ADA Curb Ramp New Construction Inspection Form (Parallel)

| | 24952.54 | | | |

PARALLEL RAMP (PL)

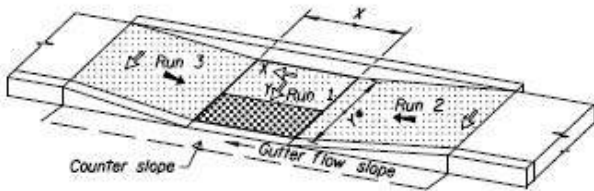
| RAMP RUN 1 | | Pass | Fail |
|---------------------------------|---|------|------|
| Counter Slope (+/-)*2 | 6.3 ≤ 5.0% <input type="checkbox"/> > 5.0% <input type="checkbox"/> | | |

Crack ramp run 3
